### Comhairle Contae Chorcaí Cork County Council

D/245/24

**DECLARATION OF EXEMPTED DEVELOPMENT UNDER SECTION 5 OF THE** RE: PLANNING & DEVELOPMENT ACT 2000 - 2010.

### S.5 DECLARATION

Photo 1

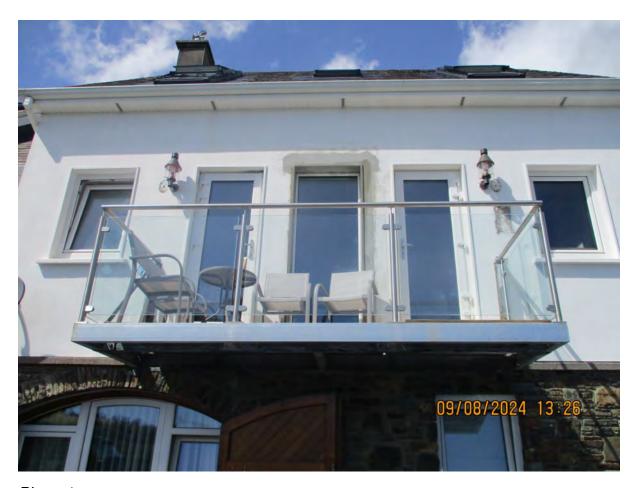
### 1. Additional window at 1st floor on front elevation (Photo 1)

The installation or construction of additional window in front elevation is development as defined in Section 2 and 3 of the Planning Acts as it does not materially affect the external appearance so-as-to render it inconsistent with the character of neighbouring structures because it is matching both existing window openings either side, and therefore complies with Section 4(1)(h) of the Planning Acts 2000 as amended.

Conclusion: Is Development & is exempted development.

Photo 3

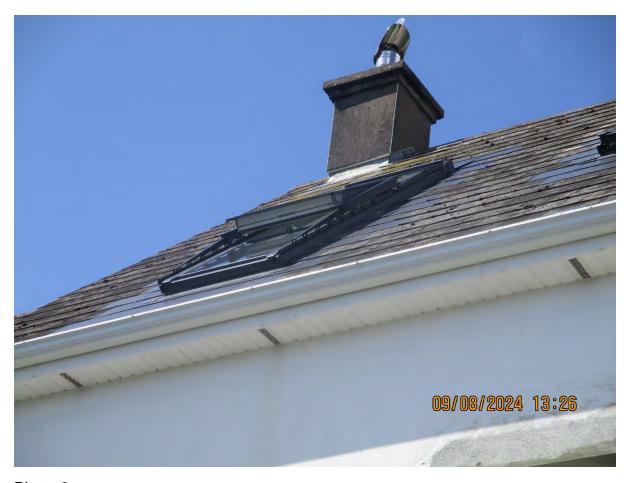
## 3. Replacement of existing velux roof lights with longer profile lights is planning exempt (photo 3).

The replacement of the existing velux rooflights with larger openings does not comply with Section 4(1)(h) of the Planning Acts 2000 as amended because the profile of the replacement frames are capable of opening and extending or protruding into existing roofscape to form balconies and rendering them inconsistent with the character of neighbouring structures.

DRAWING TITLE ARCHITECTURAL SERVICES INSTALLATION P3-1 PROPOSED NEW REAR BALCONY DETAILS IN2 REF: DRAWING No. SIZE A1 VKW VKW-IN2-01-ZZ-DR-BW-1703

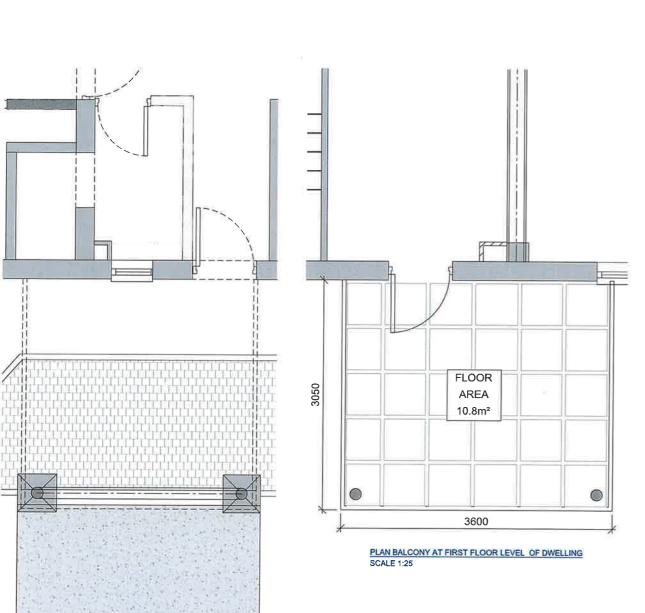
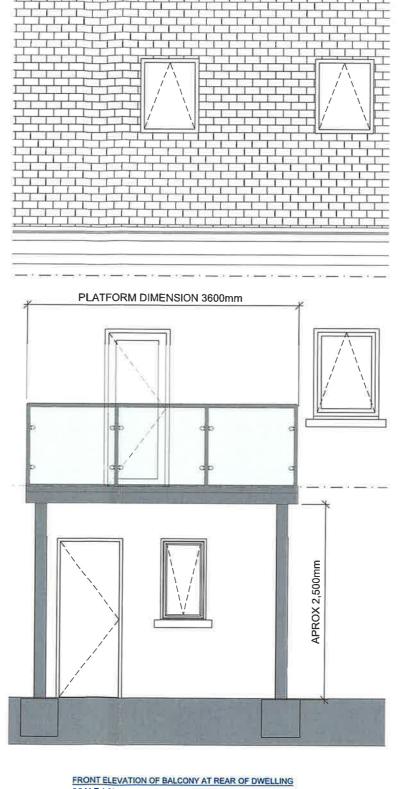
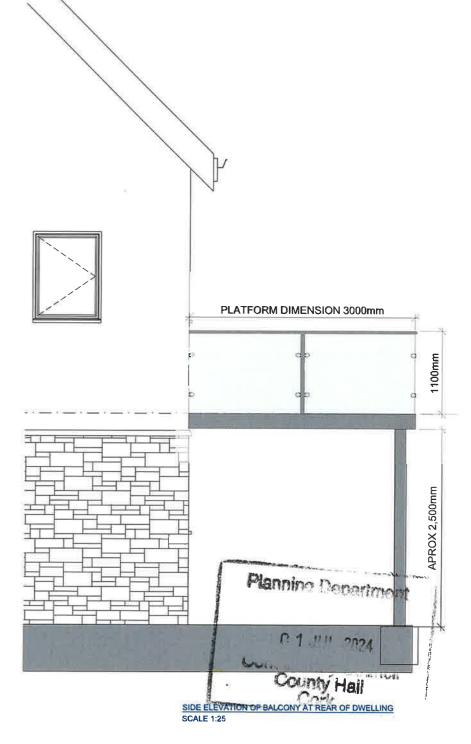
The enlargement of window to door opening is part of gaining access to an above ground terrace or balcony (9m2), both these elements cannot come within the scope of Schedule 2, Article 6, Part 1, Class 1 because they are NOT extensions, and furthermore materially affect the external appearance so-as-to render it inconsistent with the character of neighbouring structures, and therefore conflicts with Section 4(1)(h) of the Planning Acts 2000 as amended.

Conclusion: Is Development & is NOT exempted development; does not come within scope of Schedule 2, Article 6, Part 1, Class 1 of Planning Regulations 2001 (as amended) and conflicts with Section 4(1)(h) of the Planning Acts 2000 as amended.
